MAS003733_A RU 23-48

Rapid Update 658 Granturismo – Air springs Replacement

ATTENTION! This document replaces MAS003733 RU 23-46. Please discard any paper copy of the previous bulletin

DATE: AUGUST 25 2023

Components to be replaced

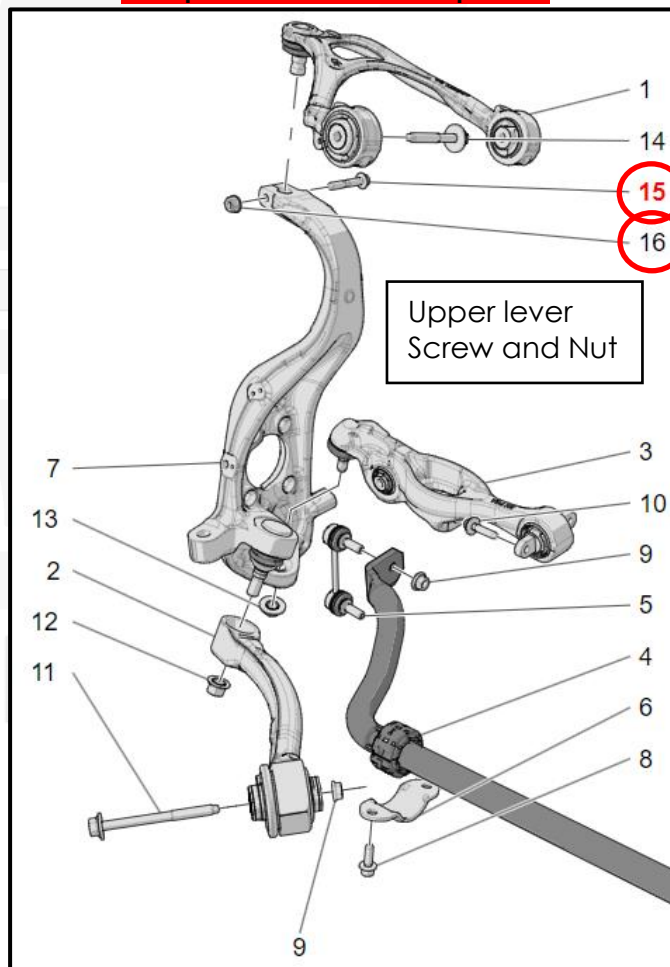
FOR THIS ACTION ONLY: Although the workshop manual states to replace the "Upper lever screw," it is not necessary for this action. See the Spare Parts Table on page 3 of this bulletin for components to be replaced.

Torque Specifications (workshop manual)	
Upper lever screw (Pos 15) NOT TO BE REPLACED	65Nm (47.9 ft-lb)
Shock absorber upper nuts (Pos 2)	20Nm (14.8 ft-lb)
Shock absorber nut(Pos 4)	1. 60 N·m (44.3 ft-lb)
	2. 142.5° (2.487 rads)
	3. 110Nm ...190Nm (81.1 ft · lb...140.1 ft-lb)

SPARE PARTS TABLE (M189)	Pos	PN	QTY
RH FRONT SHOCK ABSORBER	1	670303906	1
LH FRONT SHOCK ABSORBER	1	670303902	1
Shock absorber upper nuts	2	675001506	6
Shock absorber retaining screw	3	670159150	2
Shock absorber nut	4	675001189	2
